Differences between Prototype and Production Alamode board

Kevin Osborn Sept. 6, 2012

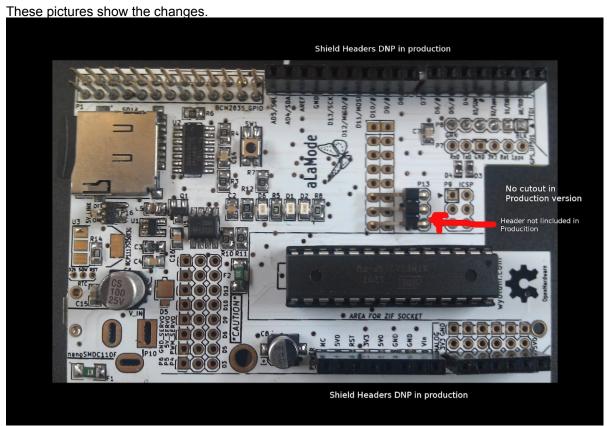
The Alamode sample provided to Seeed should be concordant with the supplied BOM, with a couple of exceptions.

- 1. Prototypes were assembled with extra programming and testing headers for development purposes. These headers will not be included in the production version.
- 2. Arduino Shield headers were soldered in. These are to be included but not soldered in the production version (DNP)

There were also minor changes made to the gerbers to aid production and usability:

- 1. Permanently linked Pins #1 and #2 of P11, U6 OE. Header and Shunt not required.
- 2. Moved Servo Headers South by 0.0750" (1.9mm) (To prevent battery socket overlap)
- 3. Moved BATT Socket North by 0.0825" (2.1mm) (To prevent battery socket overlap)
- 4. GPS header position changed to edge of board for easier attachment of optional GPS module.
- 5. The cutout on the Eastern edge of the board is eliminated.
